TECHNICAL BULLETIN

Mini, 100, 200/400, New 200, New 400

Bull. No: 0028

REMOTE HANDSET, BUTTON DAMAGE

A6957TC1

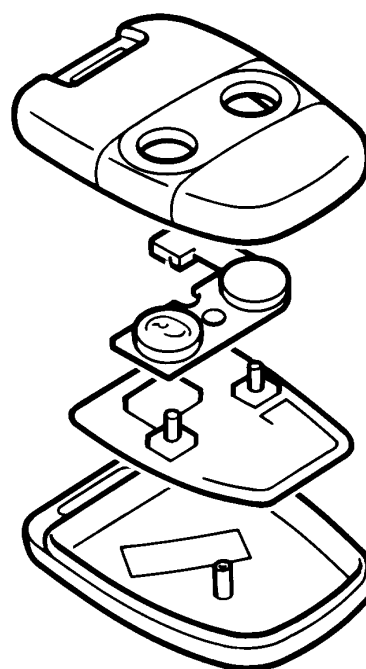
Buttons split (damage by finger nail).

Buttons stuck down (displaced and trapped under casing).

Remote handset service kit, part number YWX101010 introduced to enable button and casing replacement whilst retaining the original transmitter component. This improved housing is supplied with modified rubber buttons to prevent reoccurrence of the above problems.

- Prise original handset apart, with a small screwdriver, inserted into the cut-out at the rear (key ring end) of the remote handset.
- Using finger pressure only, prise apart the two clips holding the printed circuit board and remove it from the remote handset.

- **Press the new button moulding into the new upper casing.**
- **Clip the original printed circuit board into the new upper housing assembly taking care to align it correctly.**

- **Transfer the week/year code label from the inside of the original lower case to the new lower case.**
- **Fit upper housing assembly to the new lower casing supplied in kit.**
- **Fix appropriate type approval label (supplied in kit).**
